Access Compliance Report

Public Rights-of-Way (Curb Ramps)

Intersection ID: 12895	Main Street: ARNOLD_DR	Cross Street: GRAYBARK_AV	Location: SW
ADA ID: 3B34686F452E	Ramp Type: Para	Initial Pass/Fail: Fail	Overall Compliance: No
		Severity Score: 35

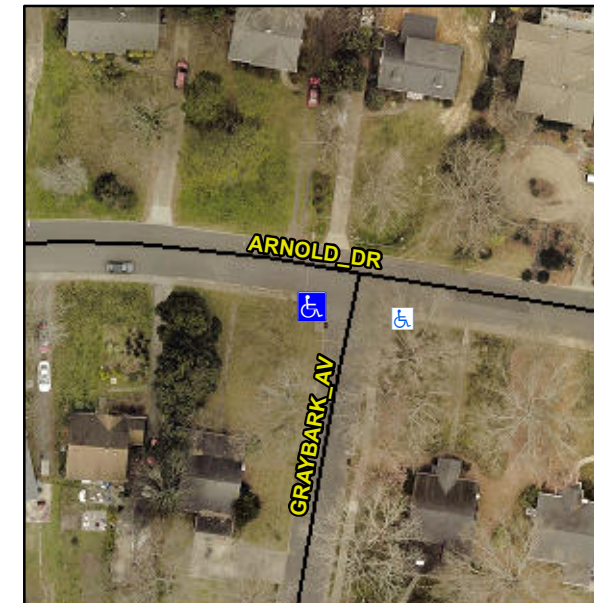
Surveyor Notes:

RT RP < 5%

PROW/ADA:

R304.5.1, R304.3.2, R304.5.3

Possible Solutions:

Remove & Replace Entire Ramp.
